Attachment 5  
to U-602512

50.59 Thermo-Lag  
Safety Evaluations

1.4 Title: EVALUATION OF THERMO-LAG IN FIRE ZONE A-1a

USAR Appendix E and F Revision

FIGURE 4.2.4.4-1  
FIRE PROTECTION DEVIATION  
AUXILIARY BUILDING  
BASEMENT FLOOR PLAN  
EL. 707'-6"  
FIRE AREA A-1

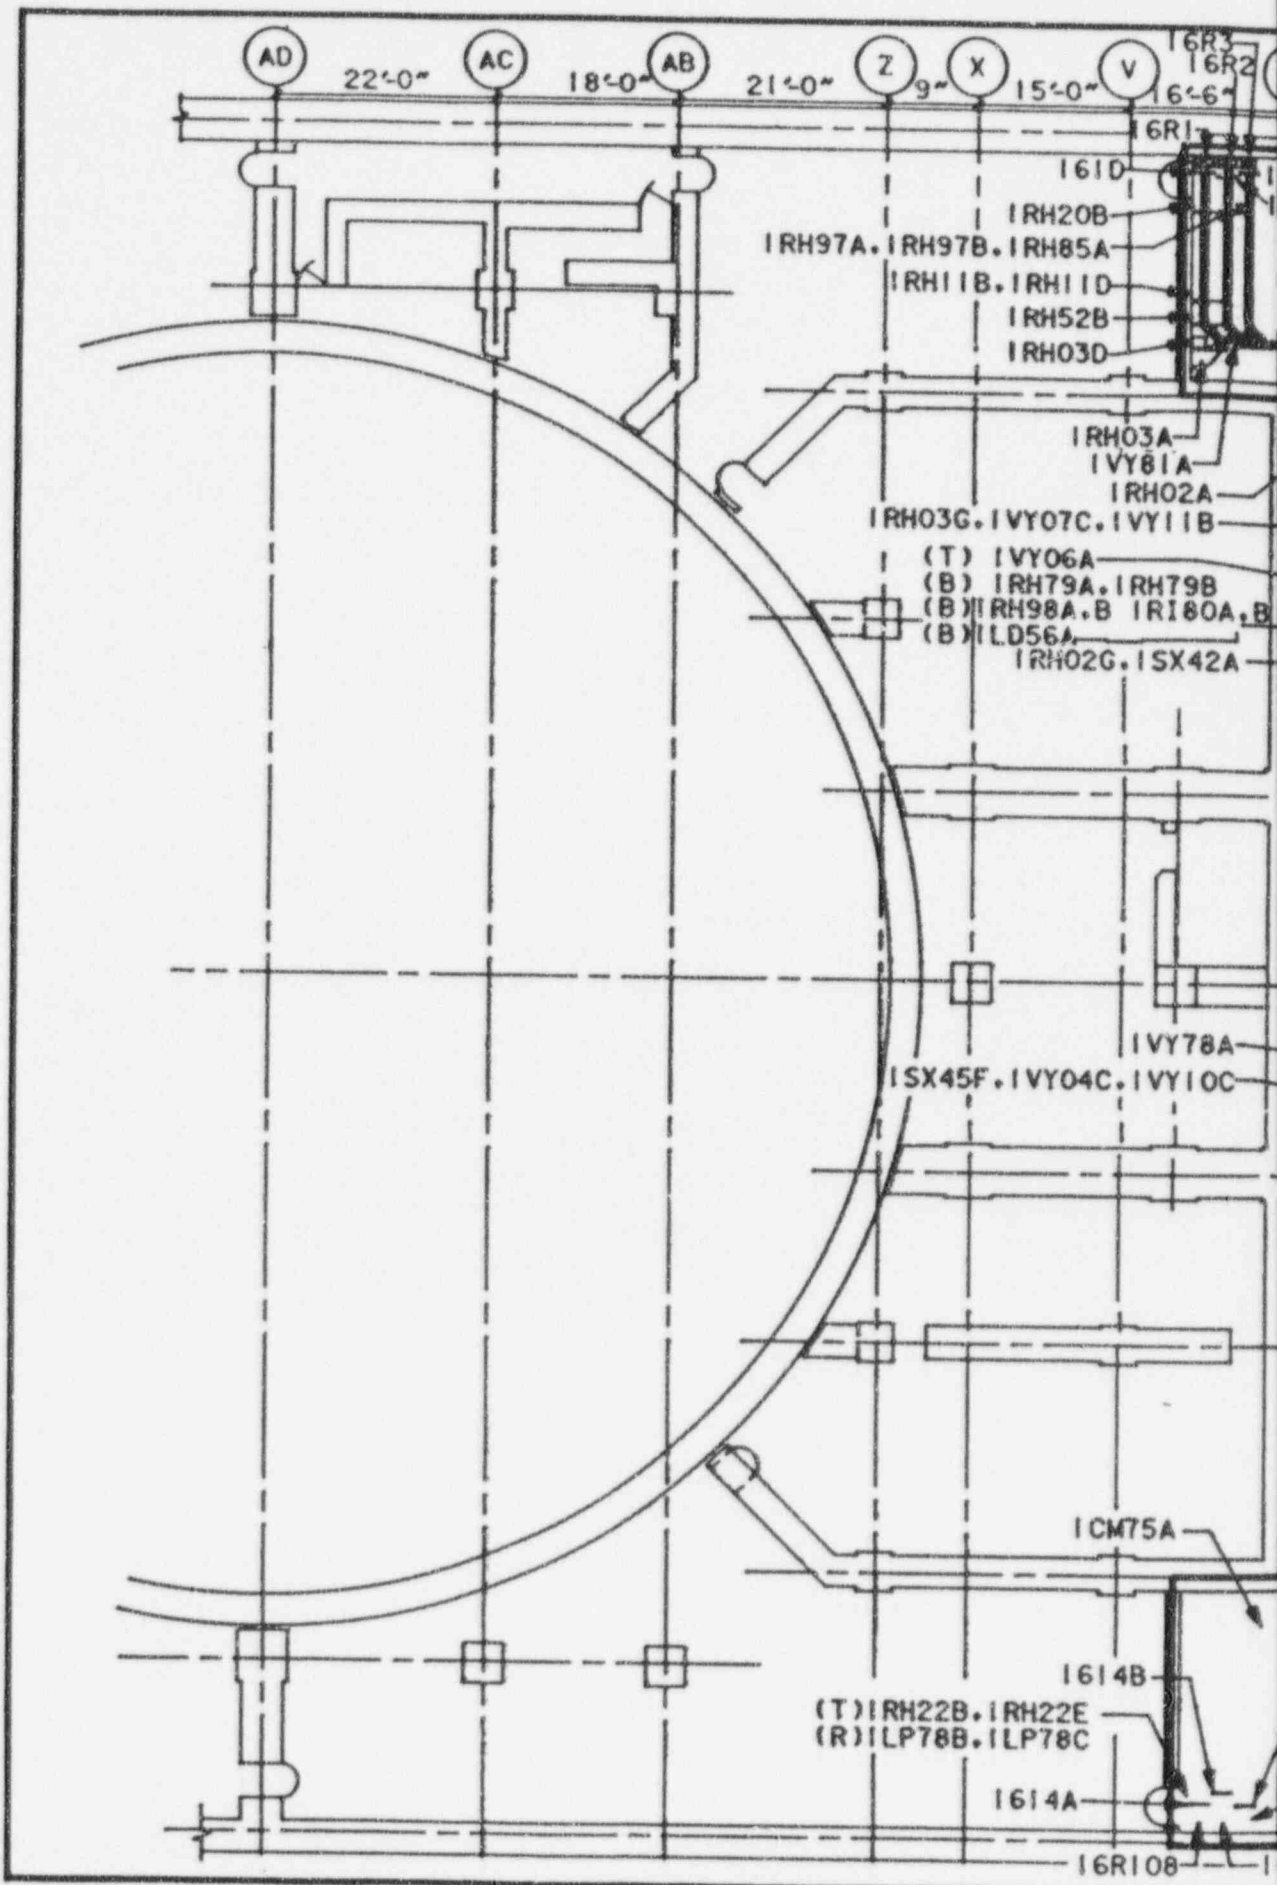
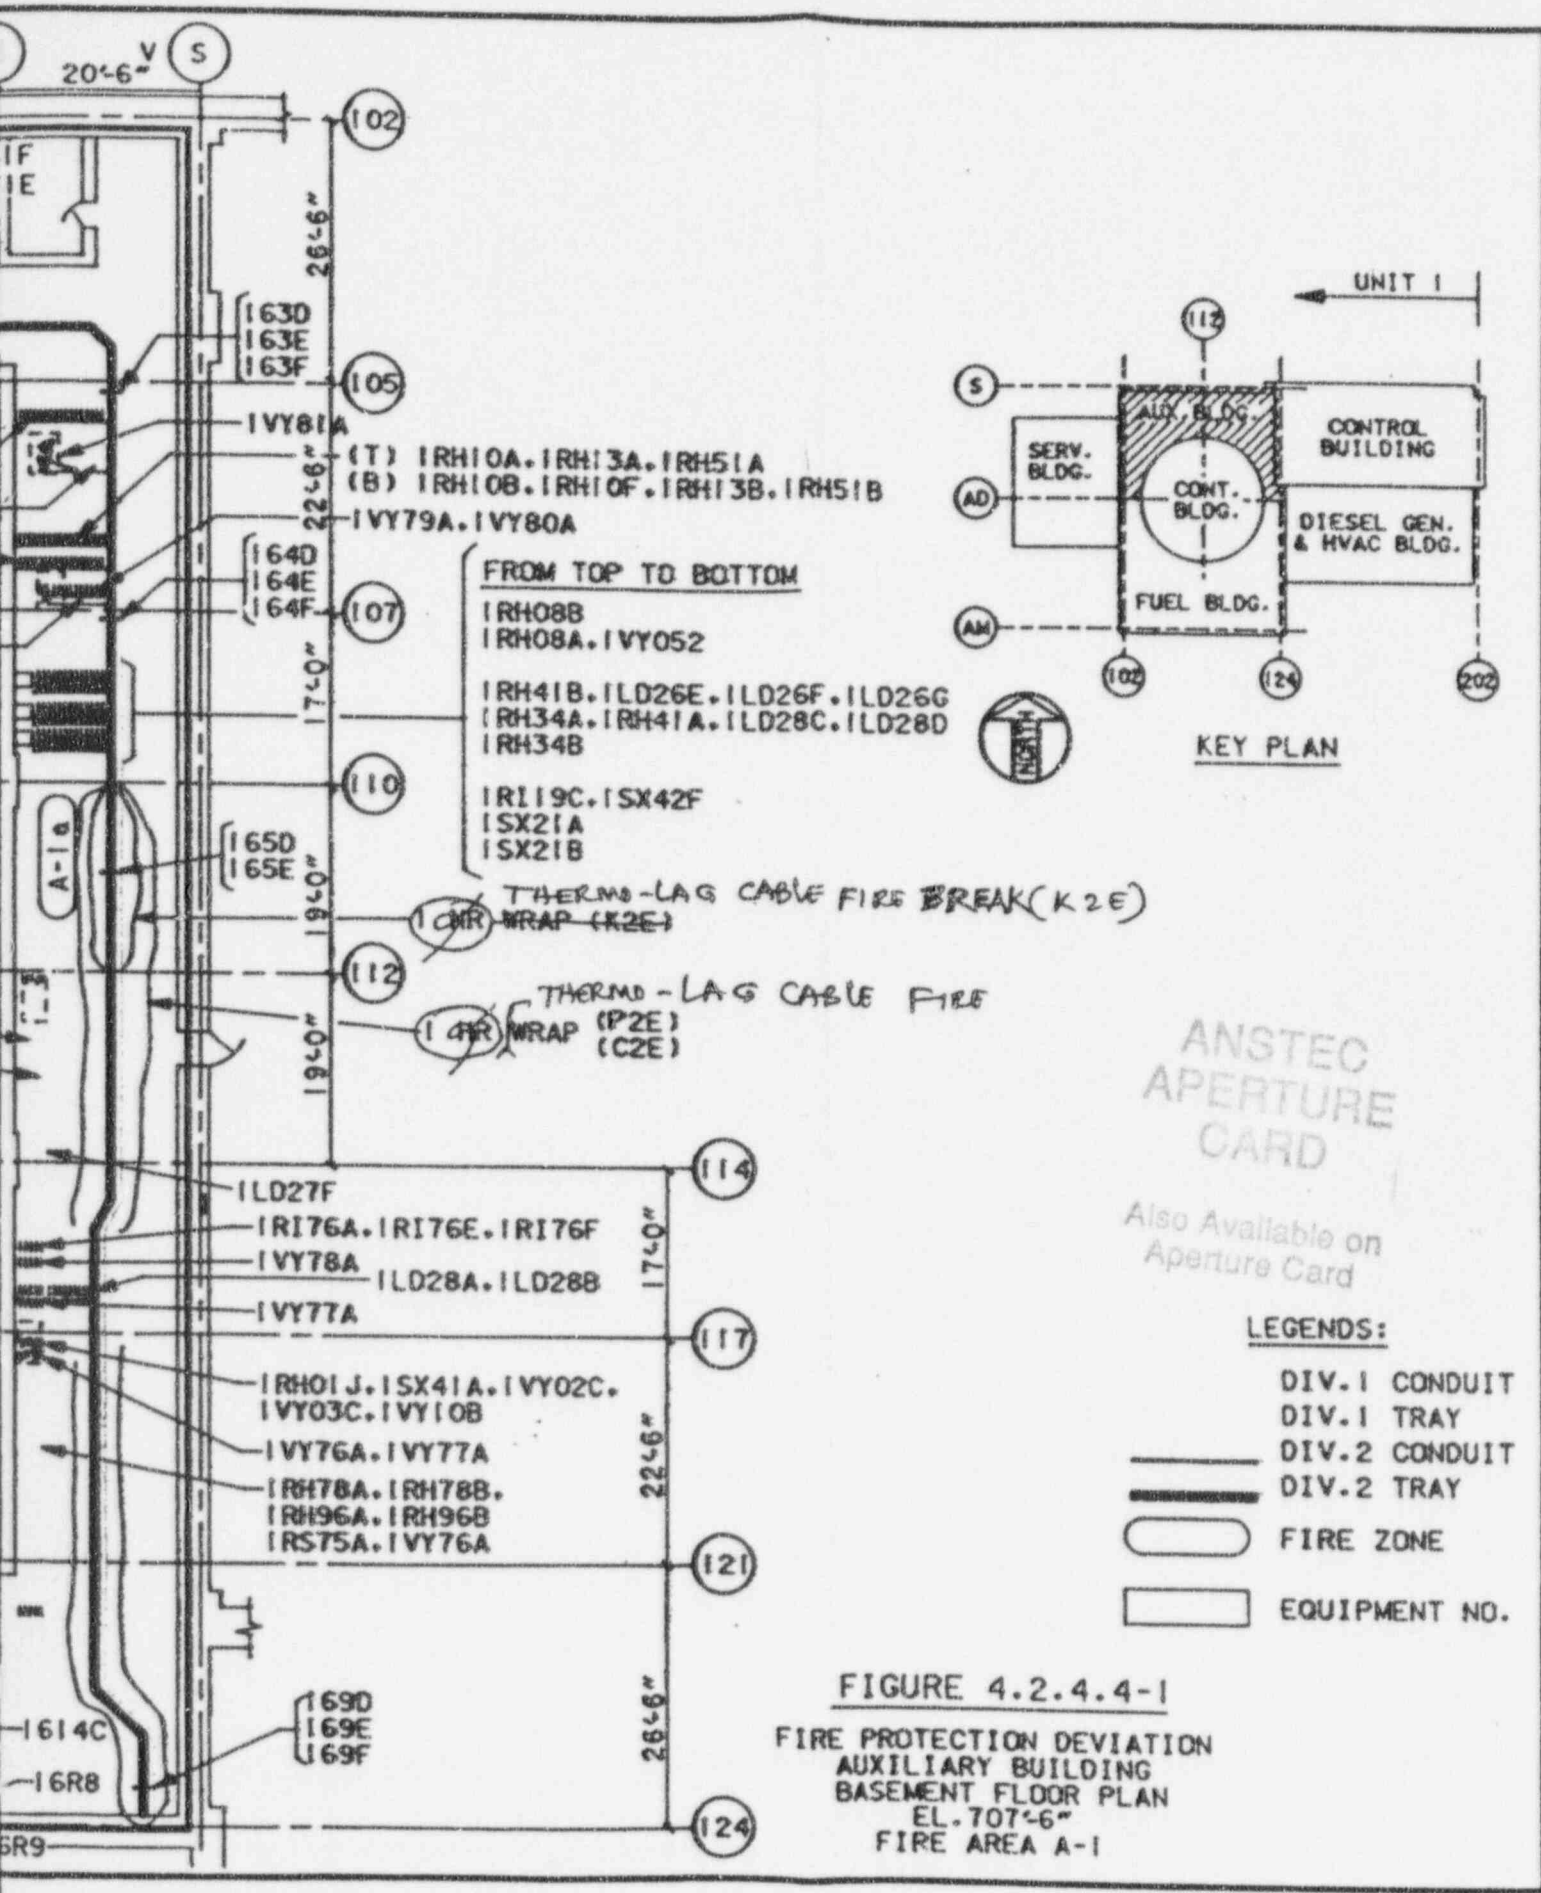
CPS USAR Appendix F, subsection 3.3.1.3 discusses the provision of 1-hour rated cable fire wrap to protect Division 2 power, control and instrumentation cables in fire zone A-1a, which is a general access corridor at elevation 707 feet 6 inches in the Auxiliary Building. The purpose of this evaluation is to accept the fire wrap as-is even though the fire wrap material used in A-1a, Thermo-Lag 330-1, does not provide the 1-hour rating. The proposed USAR change will delete the reference to the 1-hour rating of the fire barrier. In addition, this deviation from Appendix R requirement for 1-hour rated fire barrier will be included in USAR Appendix F, Section 4.2.

The proposed deviation is from the requirement of 10CFR50, Appendix R, Section III.G for a 1-hour fire barrier. It is proposed that the USAR delete references to the 1-hour rating of the Thermo-Lag fire wrap in fire zone A-1a.

FIGURE 4.2.4.5-3  
FIRE PROTECTION DEVIATION  
CONTROL BLDG. INTERMEDIATE  
ROOF PLAN EL. 751'-0"  
FIRE AREA CB-1

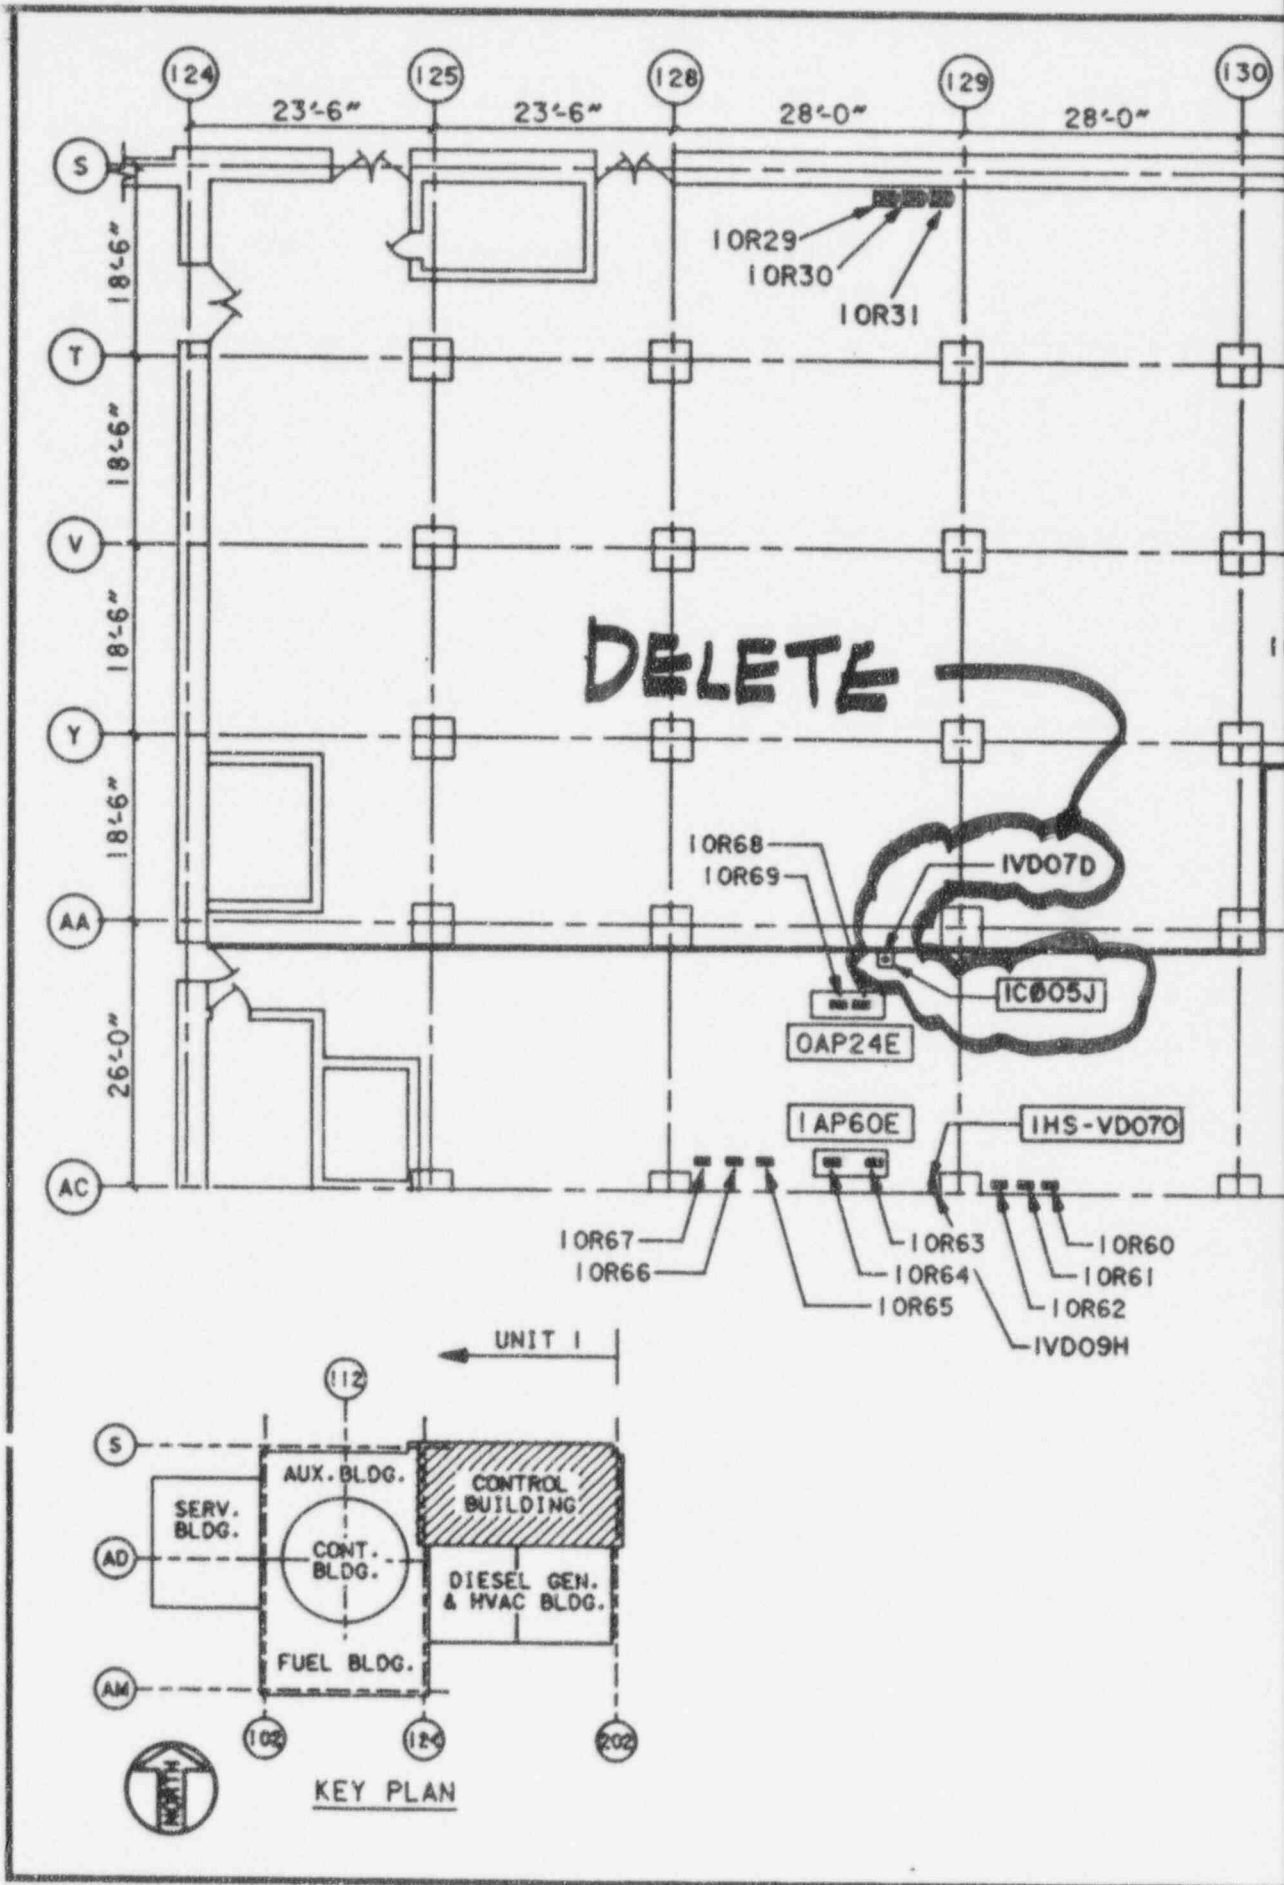
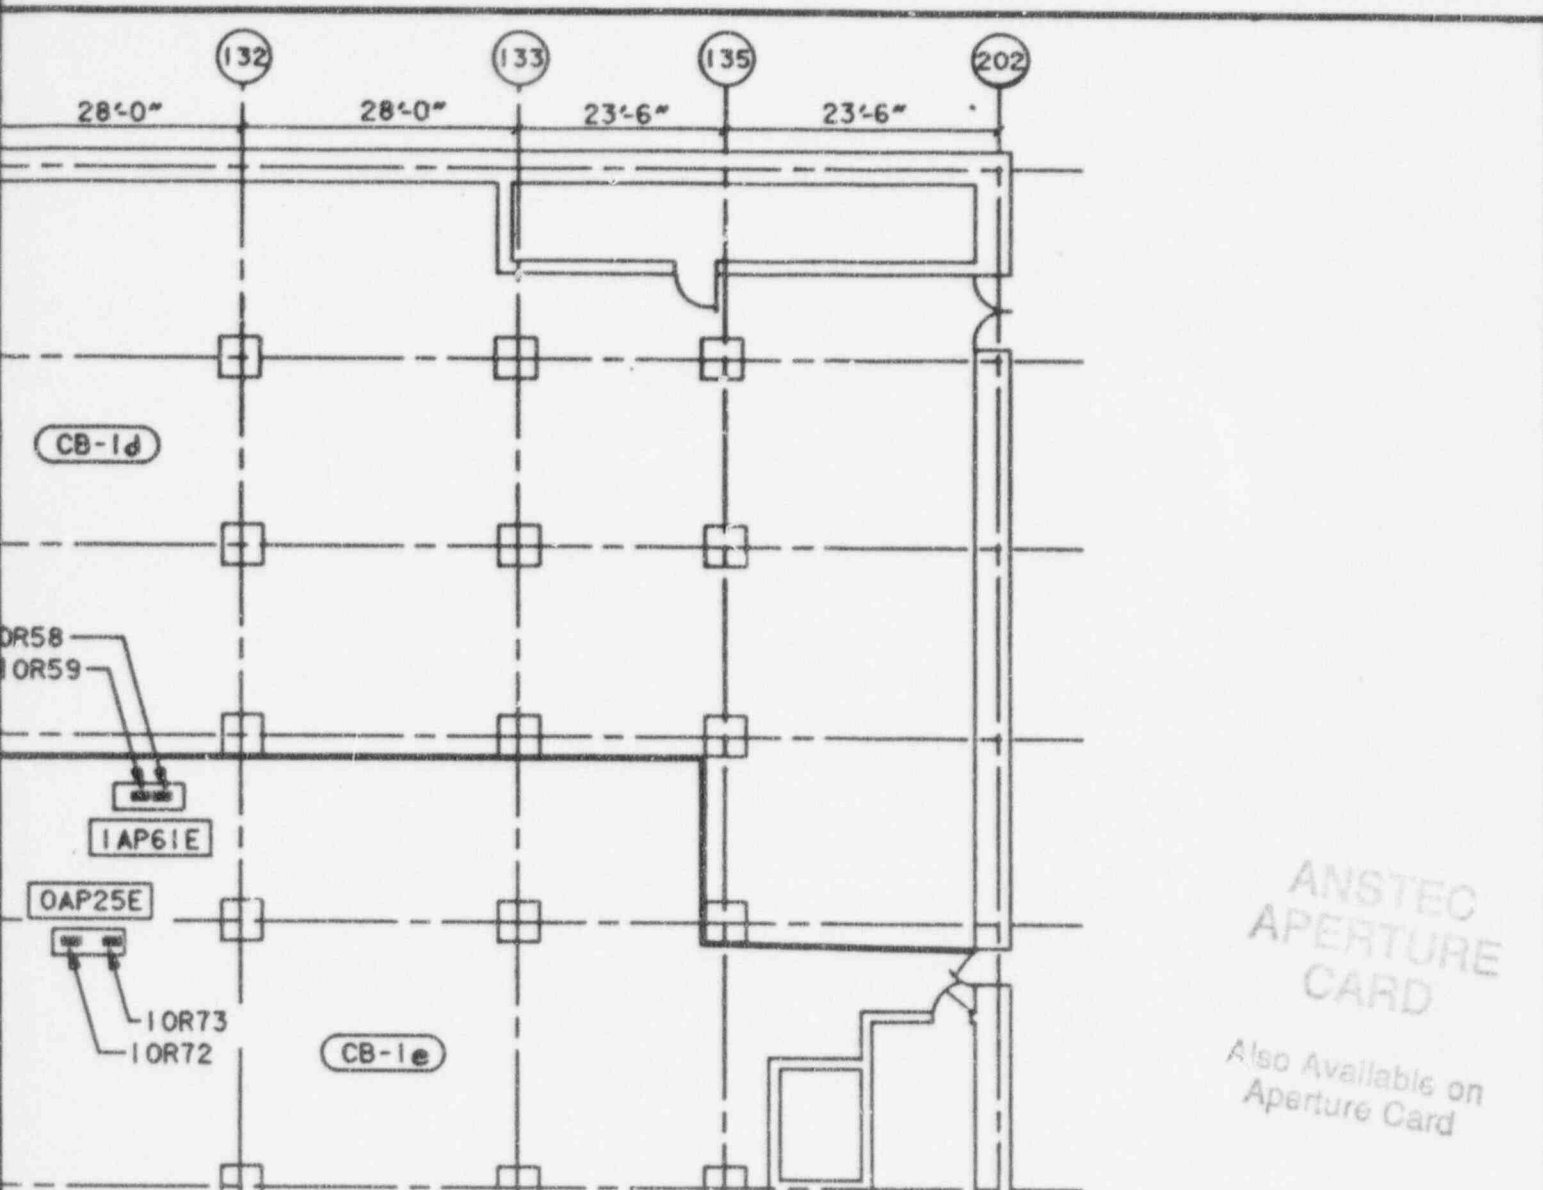
In Fire Zone CB-1e, elevation 737 feet 0 inch (see Figure FP-10a) and above the intermediate roof at elevation 751 feet 0 inch (see Figure FP-11a), Division 1 and 2 electrical cables that belong to the diesel generator, diesel generator HVAC, auxiliary power, shutdown service water, control room HVAC, and the diesel generator fuel oil systems are routed in cable trays within a distance of less than 20 feet (see Cable Tray Figure 9). Also, located in this fire zone are diesel generator building MCCs 1A and 1B. In order to ensure that one shutdown method will be available, the Division 1 and 2 cable trays will be protected as described in Subsection 3.3.1.3.2.
